Amendments to the Drawings:

09/131,593

FIG. 6

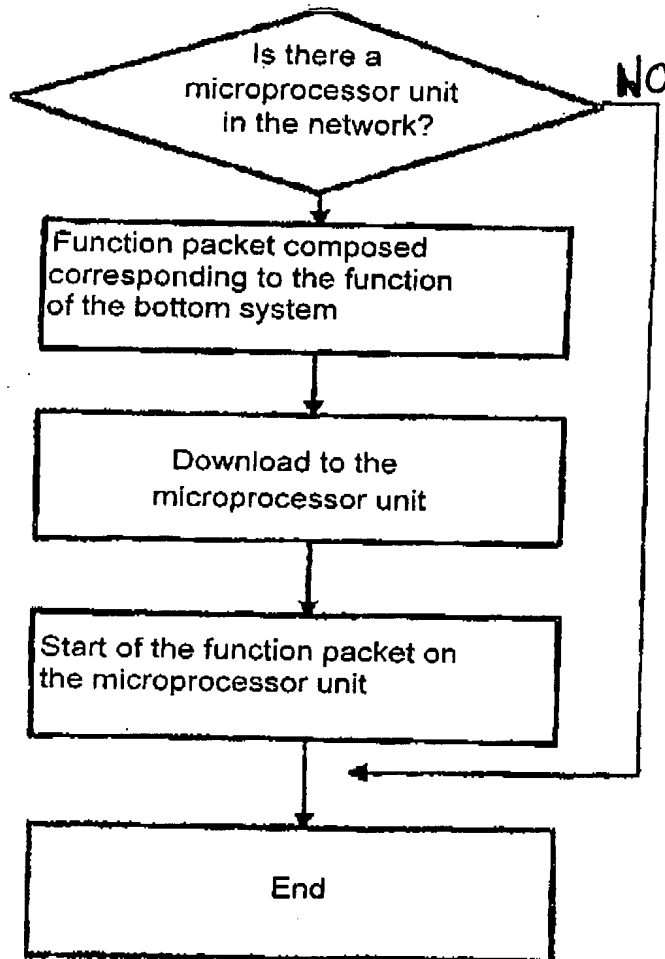
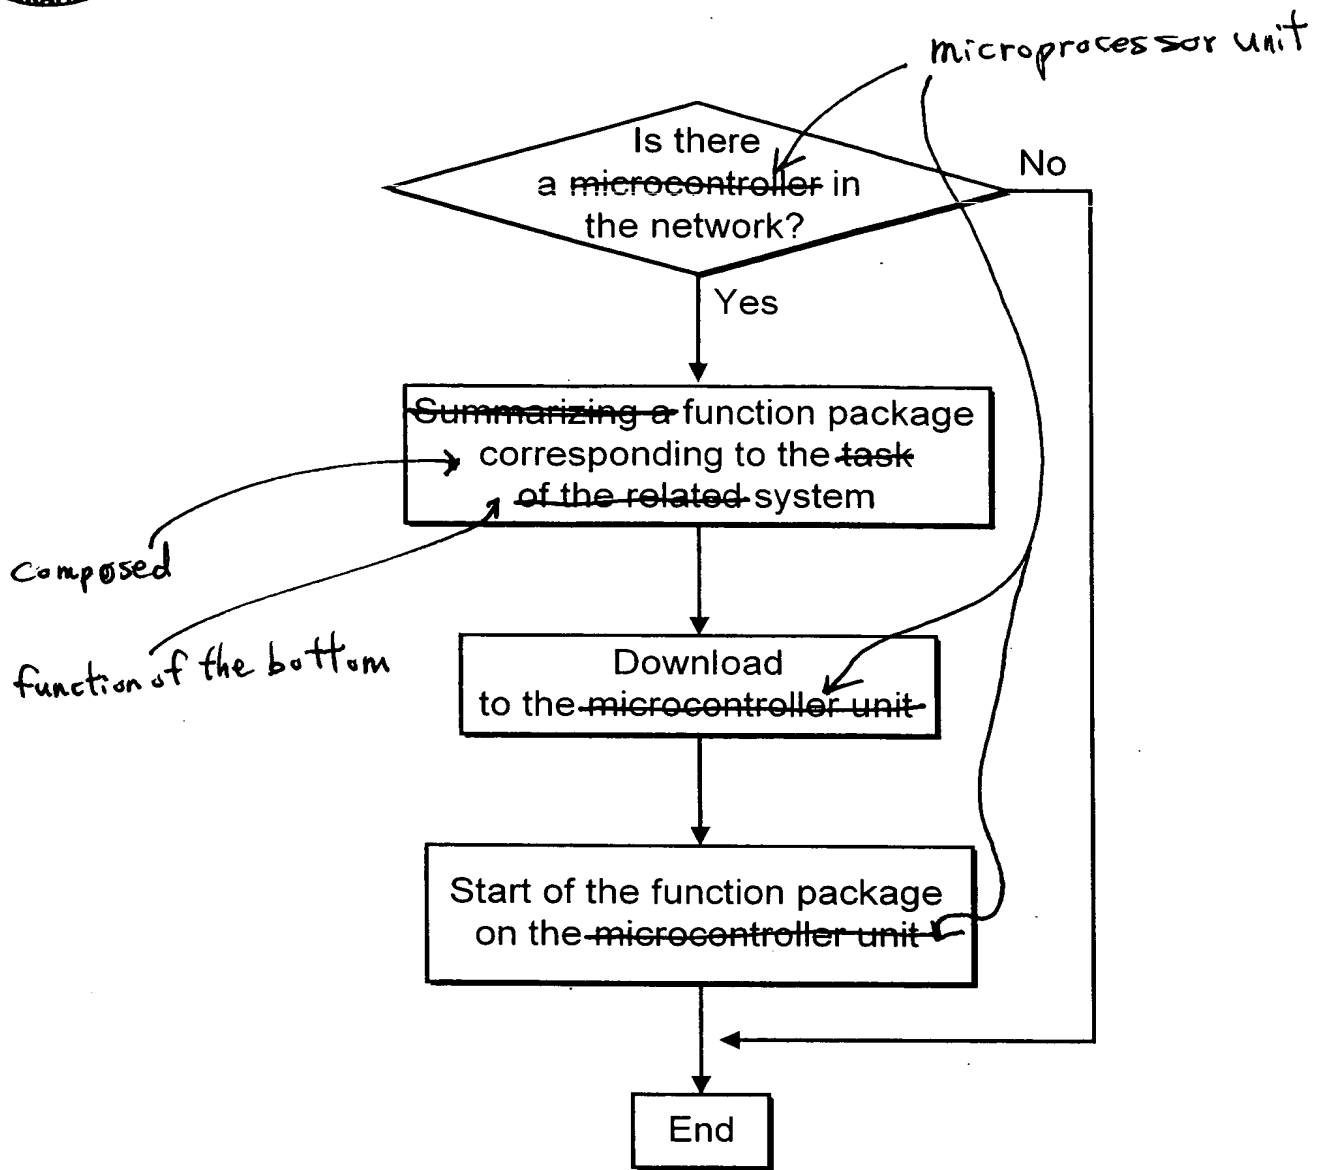
The attached sheet of drawings includes an addition of FIG. 6 which is being resubmitted for approval. Minor changes have been added such as replacing “microcontroller” with “microprocessor”.
